Mini Holland Cycle Scheme

Stage 1 Road Safety Audit

Ref: 2524/032/A105/BOR/2016

London Borough of Enfield

FILE: PROPOSED A105 ROUTE SHEET 10	
SCALE: NTS	DRAWING NO: B240G001-SK-A105-001-10
REV: E

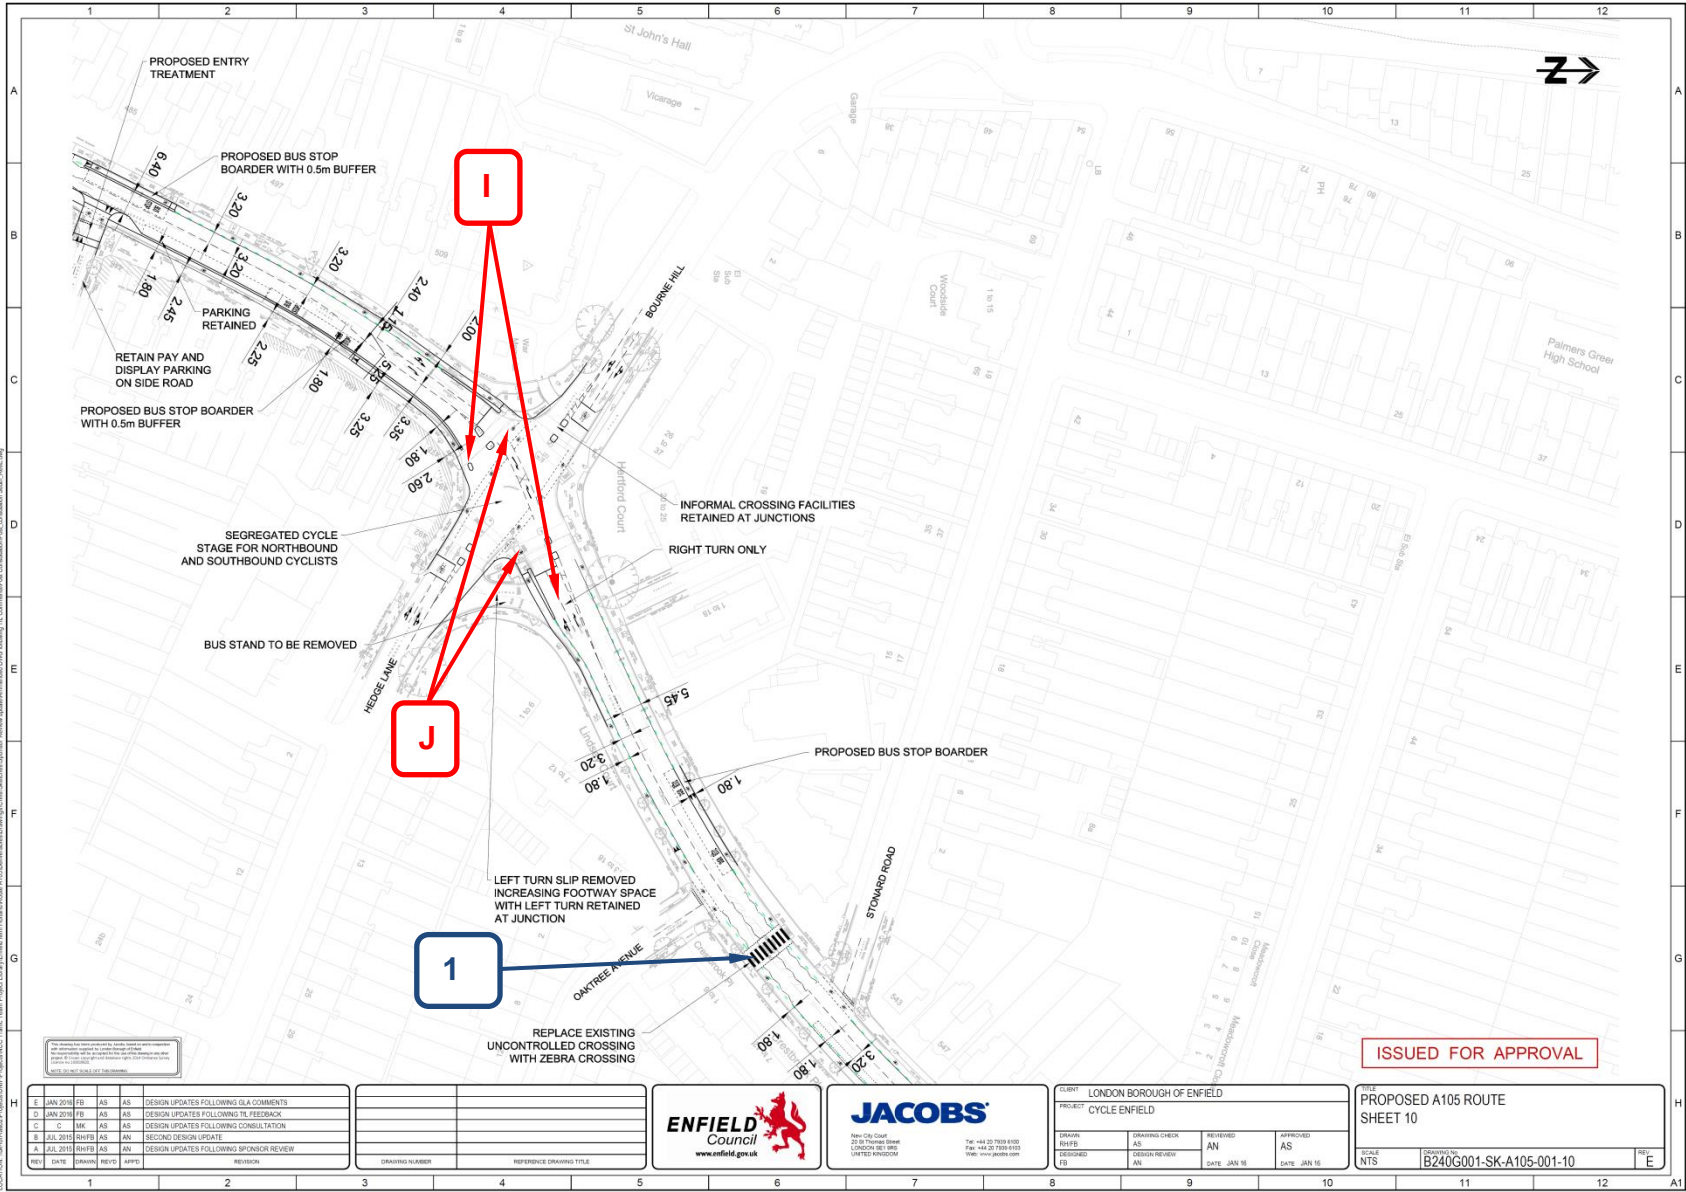
3.7 DRAWING 001-10

Location: 10 - Drawing 001-10 – Zebra crossing south of Stonard Road

Design Organisation Response	Part Accepted
<p>The island separating cycles from traffic on the southbound approach has been widened to 1.20m (previously 1m). In order to retain the cycle lane width on the approach, the proposed triangular island has been trimmed. This island will have a signal head located on it.</p> <p>The island separating cycles from traffic in the northbound direction has been widened to 1.20m on the approach (previously 1m), with the cycle lane width reduced to 1.50m. This island will have a signal head located on it.</p> <p>Regarding the island on the A105 SB exit, it is there to accommodate a wand and not a signal therefore the proposed 1m width is sufficient.</p> <p>The cycle track south of the junction in the southbound direction has been raised to</p>

Design Organisation Response	Rejected
<p>As cycle flows are expected to be low on the A111 Hedge Lane/Bourne Hill and as there is no signal detector for cyclists (to date), the cycle early release phase would have to be called even if no cyclists were present. This would have a significant negative effect on the capacity of the junction which is already at high saturation levels. The designers have been in contact with TfL -Traffic Infrastructure who have confirmed that 2SRT can be implemented without an early release as the geometry of this junction is such that 2SRT cyclists on both Hedge Lane and Bourne Hill will have adequate distance to head-start in front of traffic, even without the early release.</p> <p>Cyclists along the A105 will not need to turn right in two stages as both the NB and SB cyclists run together in Stage 1 while all traffic movements are held (separation of cyclists from traffic 'in time').</p> <p>Signage will be provided on the approaches to make cyclists aware of the 2SRT facility.</p>

Design Organisation Response	Rejected
------------------------------	----------

FILE	PROPOSED A105 ROUTE SHEET 11
SCALE	NTS
DRAWING NO.	B240G001-SK-A105-001-11
REV.	E

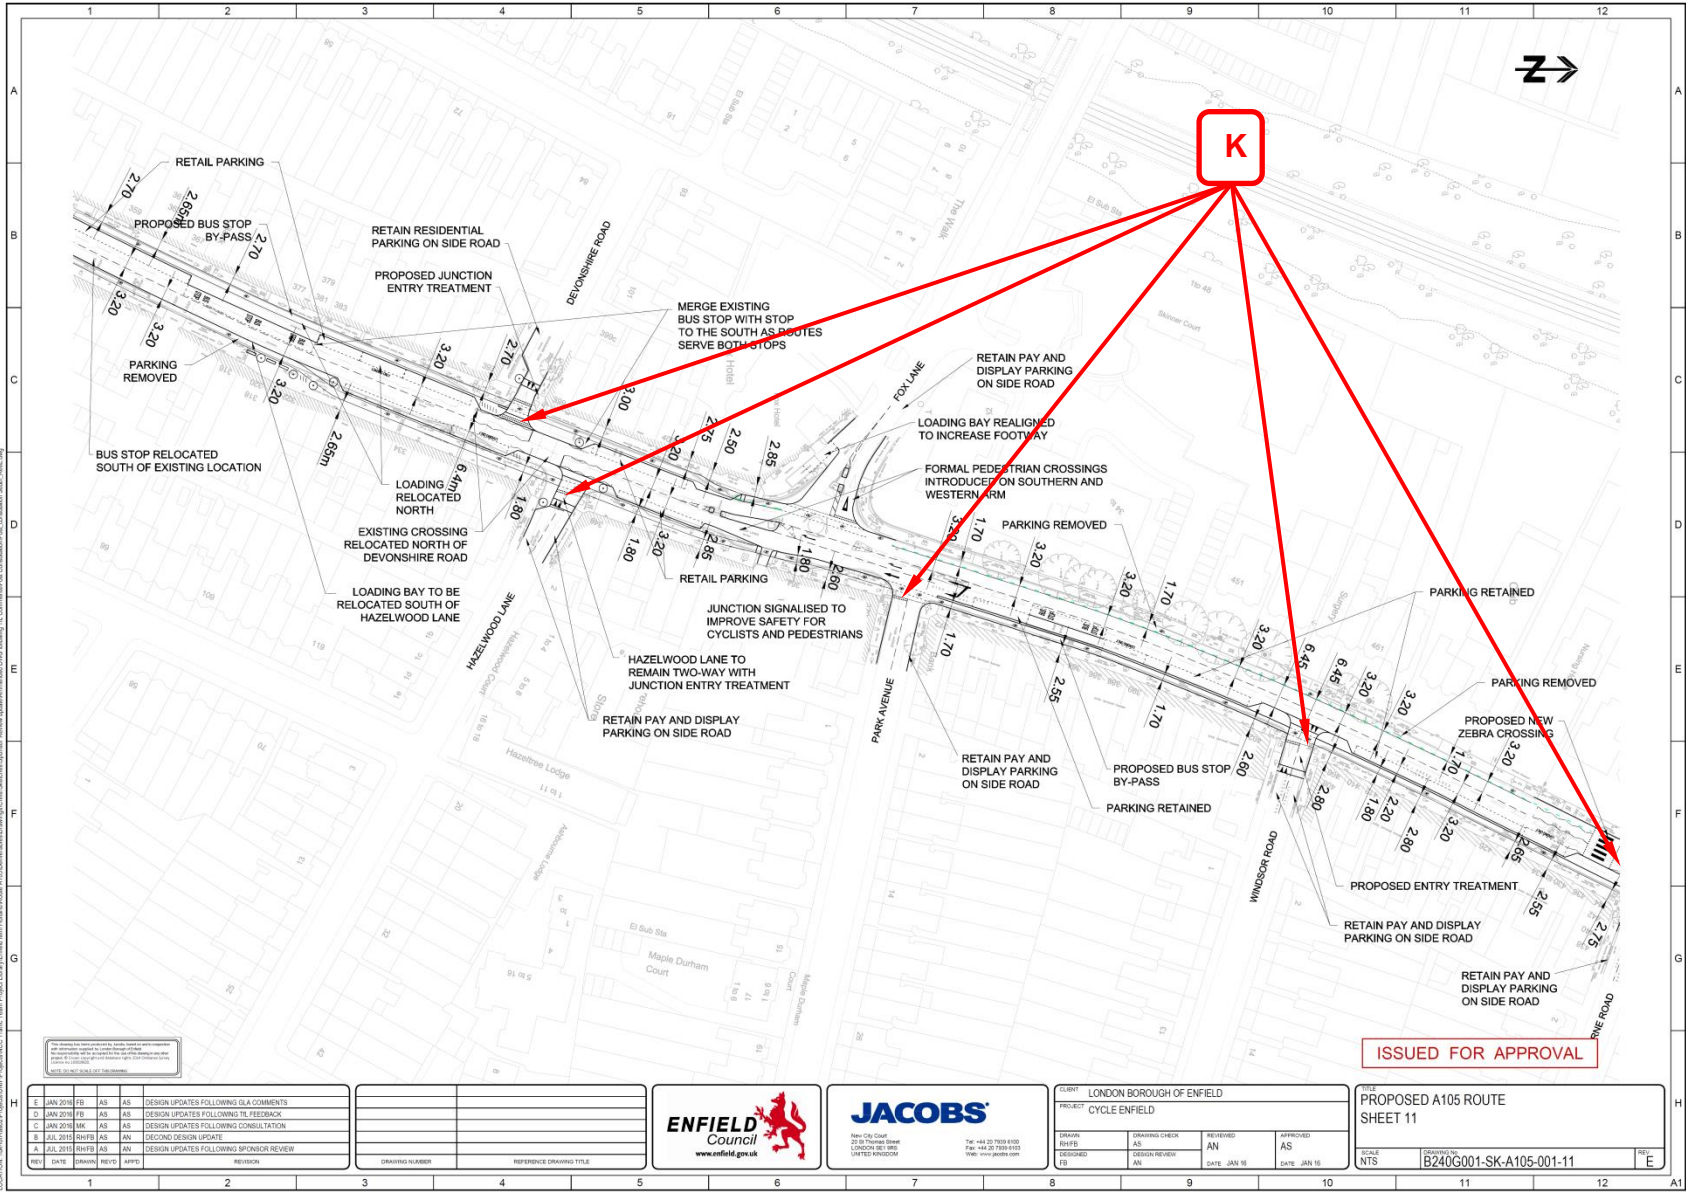
3.8 DRAWING 001-11

Design Organisation Response	Part Accepted
<p>Parking has been retained as much as possible, where possible, to minimise the loss of parking in the high street areas.</p> <p>Carriageway widths have been reduced, which will in turn reduce average vehicle speeds on the A105. All side roads along this section (excluding Park Avenue) have side road entry treatments, which will further reduce speeds of turning vehicles.</p> <p>We would also expect to see a behavioural change for all road users given the introduction of the transformational cycle facilities along the length of the corridor.</p> <p>For a short period after implementation signage will be provided to warn drivers of layout changes, for a short term.</p>	
Client Organisation Comments	
<p>Designer's response accepted.</p>

FILE	PROPOSED A105 ROUTE SHEET 12	
SCALE	NTS	
DRAWING NO	B240G001-SK-A105-001-12	
REV	E

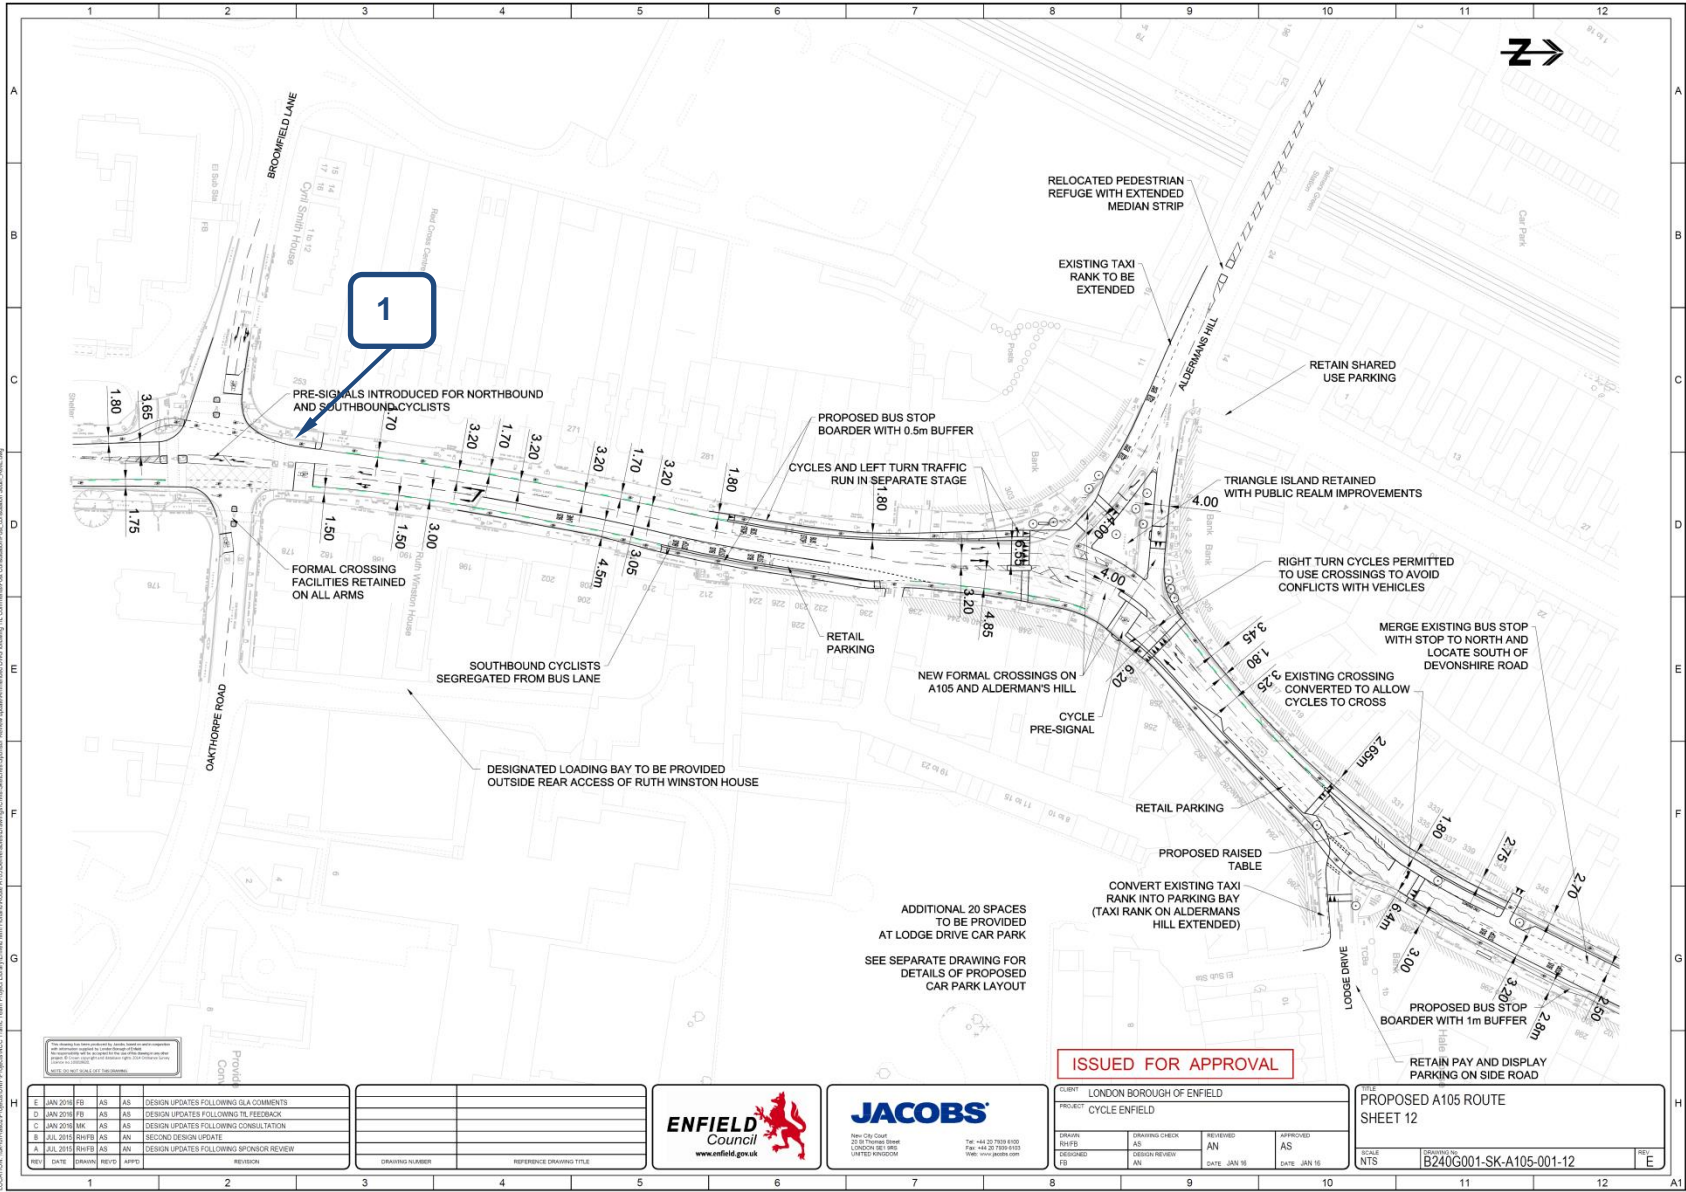
Location: 11 – Drawing 001-12 – At the junction of Green Lanes with Broomfield Lane

Design Organisation Response	Rejected
------------------------------	----------

Due to capacity constraints at the junction it is not possible to provide a separate stage for cycling, to segregate them from traffic. The southbound left turn movement for general traffic is low and therefore an early release is considered an acceptable provision for this approach. However, the northbound approach has a heavy left turn and therefore simply providing an early release is not considered sufficient provision. The proposed junction operates with the northbound cycle phase running in the same stage as the pedestrian crossings. If cyclists were on carriageway, they would be in conflict with the pedestrian crossings on the A105 northern arm.

TITLE: PROPOSED A105 ROUTE SHEET 13	SCALE: NTS	DRAWING NO: B240G001-SK-A105-001-13	REV: E
-------------------------------------	------------	-------------------------------------	--------

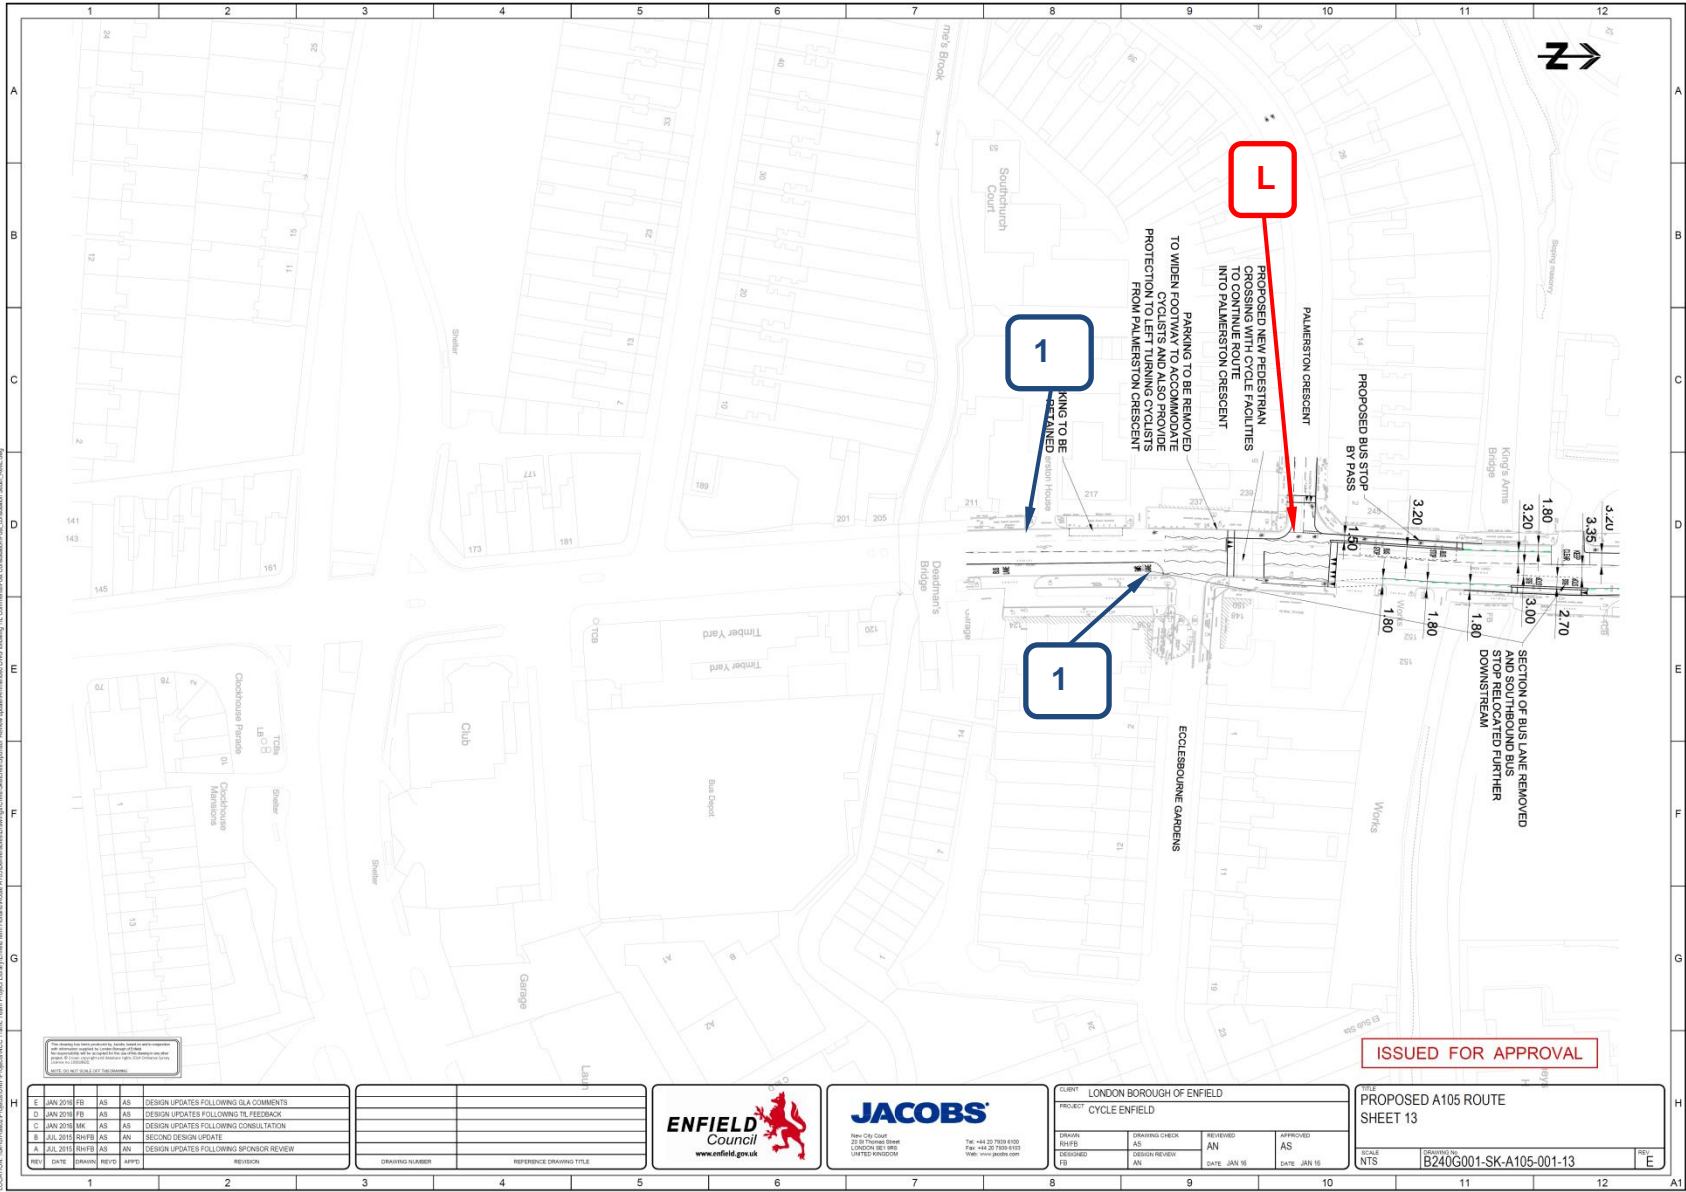
3.9 DRAWING 001-13

Location: 12 – Drawing 001-13 – Green Lanes south of Palmerston Crescent

Location: 13 – Drawing 001-13 – Green Lanes south of of Ecclesbourne Gardens

Design Organisation Response	Accepted
Accepted design change. The kerblineline on the raised junction area has been redesigned so that the cycle lane remains at all times on the carriageway side to eliminate the ambiguity regarding the cycle manoeuvre at the junction mouth.	
Client Organisation Comments	
Designer's response accepted.

Design Organisation Response	Accepted
-------------------------------------	-----------------

The design has been amended to provide a single lane northbound between the advisory crossing adjacent to 201 Green Lanes and Palmerston Crescent. Lane markings have been amended to tie in with the existing lane arrangement south of the scheme extents.

Design Organisation Response	Accepted
-------------------------------------	-----------------
